## TECHNICAL SERVICE BULLETIN

TITLE:  
DRIVE WHEEL ASSEMBLY

APPLICABLE MACHINES:  
528

REAR WHEEL DRIVE MOTORS

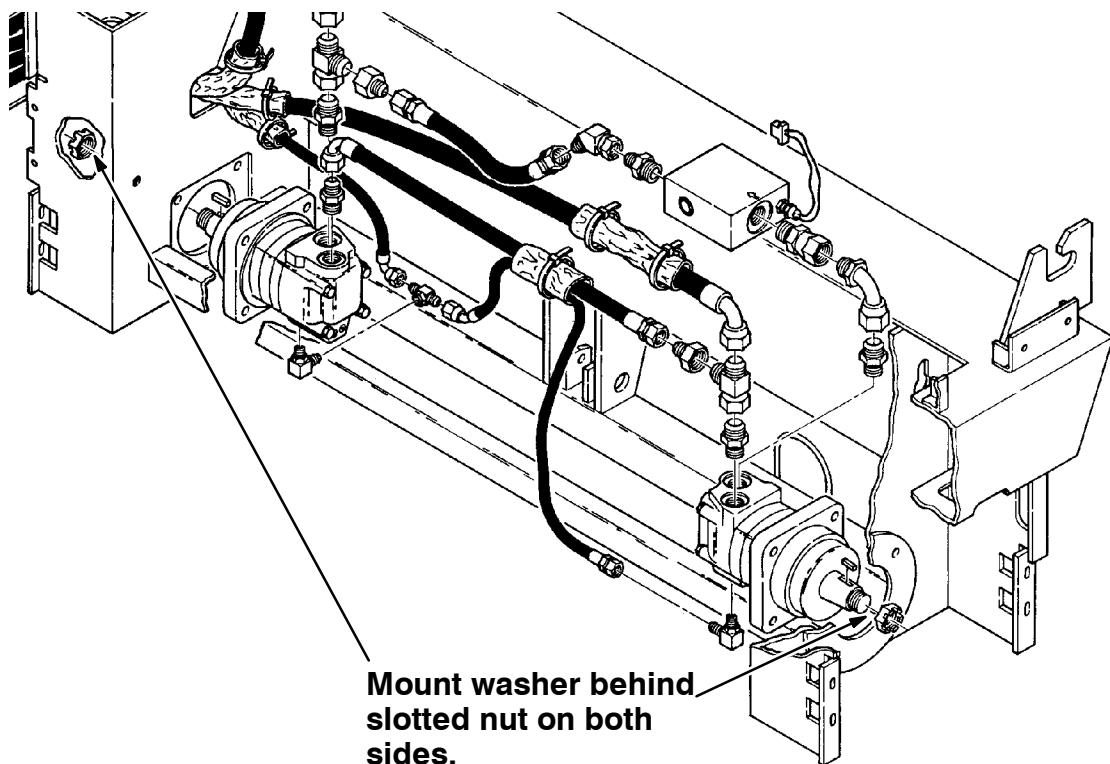
**SYNOPSIS:**  
Adding a washer to protect the wheel hub and drive motor shaft.

Machines, serial number 30279 and below, need a flat washer, TENNANT part number 32598, added behind the slotted nut on the drive motor shaft. Without the washer, the slotted nut could turn-out and damage the wheel hub and/or motor shaft.
